Change Description

Product Name: EZ-BLE PRoC Module
FCC ID: WAP2005
IC Model No.:   CYBLE-222014-01/ CYBLE-222005-00
IC :   7922A-2005

CYBLE-222005-00
	CYBLE-222014-01

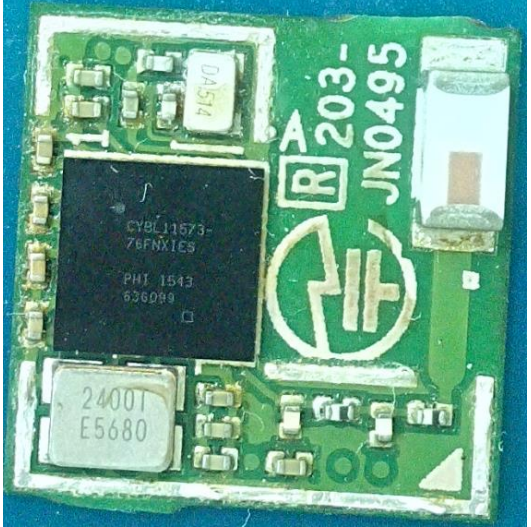
Modules CYBLE-222005-00 AND CYBLE-222014-01 have the same PCB, periphery parts and the encapsulation of the main chip. The difference of the main chip is Bluetooth version it supports.

Module	IC Part Number	CPU Speed (MHz)	Flash Size (KB)	Package	Bluetooth version
CYBLE-222005-00	CYBL10573-76FNXI	48	256	76-WLC-SP	4.1
CYBLE-222014-01	CYBL11573-76FNXI	48	256	76-WLC-SP	4.2

The RF character of these two modules is the same.
